SUBJECT: COMANCHE PEAK NUCLEAR POWER PLANT, UNITS 1 AND 2 - STAFF  
ASSESSMENT OF RESPONSE TO 10 CFR 50.54(f) INFORMATION REQUEST  
– FLOOD-CAUSING MECHANISM REEVALUATION (CAC NOS. MF1099 AND  
MF1100)

STAFF ASSESSMENT BY THE OFFICE OF NUCLEAR REACTOR REGULATION

RELATED TO FLOODING HAZARD REEVALUATION REPORT

COMANCHE PEAK NUCLEAR POWER PLANT, UNITS 1 AND 2

**Figure 3.2-1: Local Intense Precipitation Hyetograph (Staff's reconstruction of licensee's hyetograph data found in Rizzo, 2014a)**

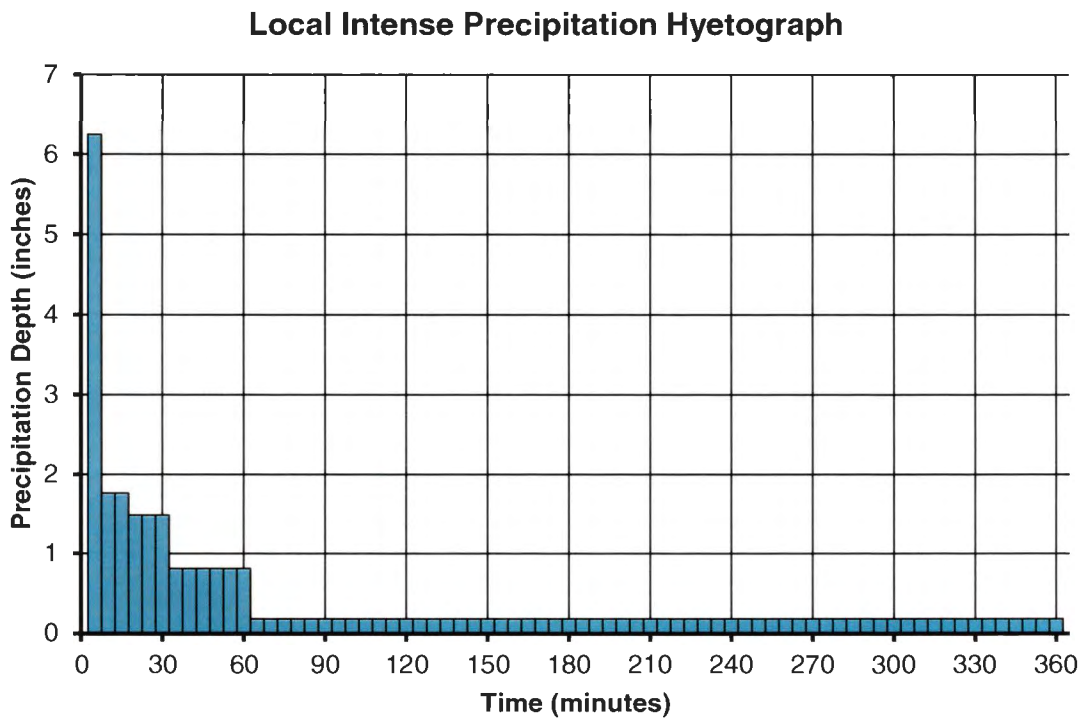
Following guidance in NUREG/CR-7046 (NRC, 2011e), the licensee determined the 1-h, 1-mi<sup>2</sup> probable maximum precipitation (PMP) using Hydrometeorological Reports (HMR) No. 51 (National Oceanic and Atmospheric Administration (NOAA), 1978) and 52 (NOAA, 1982). The licensee used a 1-h, 1-mi<sup>2</sup> PMP of 19.1 in. and 6-h, 10-mi<sup>2</sup> PMP of 30.03 in. to create a 6-h hyetograph using 5-minute increments, with values interpolated based on values reported in Rizzo (2014a). Figure 3.2-1 shows staff's reconstruction of the licensee's LIP hyetograph.

The NRC staff reviewed the licensee's results for the LIP PMP values and compared them with those in HMR 52 (NOAA, 1982) and confirmed the 6-h, 1-h, and sub-hourly PMP values. The NRC staff also confirmed the HMR 52 computer program results for the 72-h PMP. The staff notes that the licensee's approach to PMP determination is consistent with current regulatory guidance and methodologies.

**Figure 3.2-2: Schematic of Updated HEC-RAS Model for Site Drainage and LIP Analysis  
(Adapted from Luminant, 2015, Figure 2-1-2)**

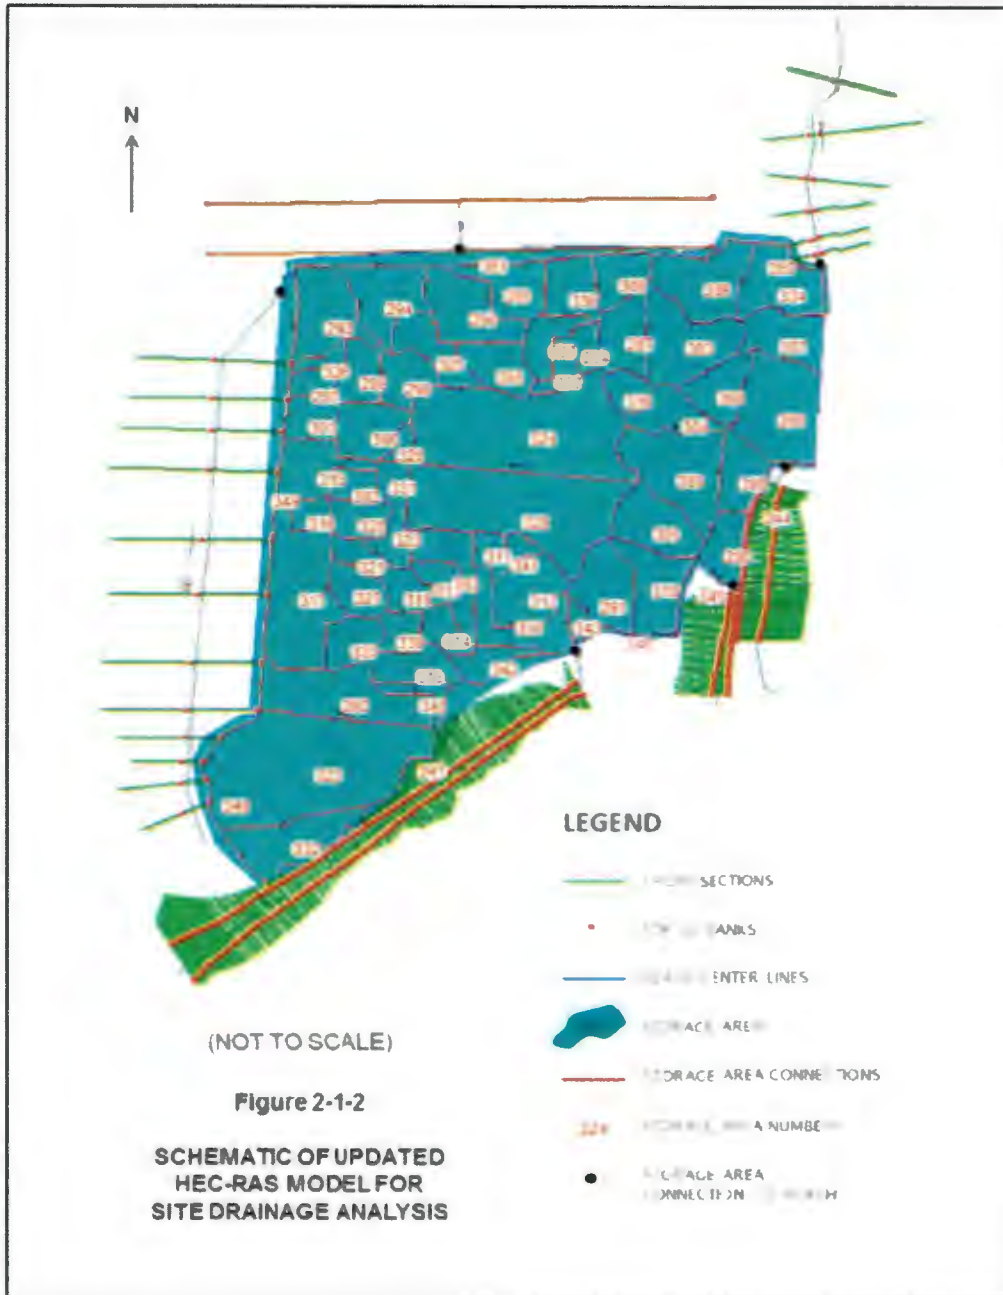
The licensee simulated potential flood water levels within the power block protected area using the Hydrologic Engineering Center - River Analysis System (HEC-RAS) model (USACE, 2010b). Figure 3.2-2 shows a schematic of the updated HEC-RAS model for site drainage and LIP analysis. The storage areas delineated for local drainage discharge in HEC-HMS and the output hydrographs were used as input into the HEC-RAS model.

The licensee used the HEC-RAS model to simulate LIP flooding across the powerblock and compute maximum water surface elevations for each storage area. The licensee's results indicate that LIP flooding remains below the critical door elevations of 810.5 ft NGVD29, with a peak water surface elevation of 810.42 ft NGVD29 at a safety-related structure (Luminant, 2015). However, the NRC staff noted several potential issues regarding the licensee's evaluation using HEC-RAS. These issues resulted in flows that do not appropriately reflect the expected physical routing of flood water across the site. Specifically, the licensee used a quasi-2D modeling approach to address the potential for undefined flow direction with overland weirs representing the connection between adjacent catchments. A weir coefficient of 3.0 was used in the model. Rizzo (2014c) states that a weir coefficient of 3.0 "is a relatively high value for the conditions represented."

The licensee's approach accumulates water in each sub-basin until the water level exceeds a boundary weir elevation. Once the water level exceeds a point along a weir, flow transfer occurs via weir flow. Based on its review, the NRC staff determined that the quasi-2D approach allows for rapid transfer of water across sub-basins in a manner that does not reflect expected physical routing of flood waters. Moreover, the manner in which the quasi-2D approach accounts for the storage area dimensions and lumps characteristics leads to temporal and spatial flow distribution that do not reflect expected physical routing of flood waters. In addition, staff finds that a reach representing flow to the SCR from a north catchment outside the VBS presents a mechanism for flow transfer that do not reflect expected physical routing of flood waters. Specifically, the modeling of several VBS openings led to fast storage area flow transfer and allowed for water to quickly move to the model perimeter. Once at the model perimeter, water enters a dummy reach and exits from the model.

After examining the model setup and the approach used by the licensee, the NRC staff determined that the simulated flood water exits the model prematurely, resulting in water elevations that are low compared to what might be expected using an alternate modeling approach.

The staff also conducted an independent analysis using the surface water flow model FLO-2D Build No. 14.03.07 (FLO-2D, 2014) and found maximum water surface elevations to be higher than predicted by the licensee. The staff's independent analysis supported the staff's conclusions regarding the issues noted above regarding the licensee's use of the HEC-RAS model.

Based on the results of the examination of the licensee's LIP model, staff's independent analysis, and identification of the issues related to the licensee's model, the NRC staff and management held subsequent meetings as part of a regulatory audit with the licensee to determine a path forward regarding the licensee's LIP modeling approach. As a result of the discussions the staff and the licensee agreed that a higher water surface elevation of 810.6 ft

NGVD29 would be appropriate for use as the reevaluated LIP flood level (Luminant, 2016; NRC, 2016b). This water surface elevation of 810.6 ft NGVD29 is the simulated water level at the non-safety-related TB 1.

Therefore, the staff concludes that a reevaluated flood level of 810.6 ft NGVD29 is a reasonable estimate of the LIP flood hazard (NRC, 2016b; Luminant, 2016).
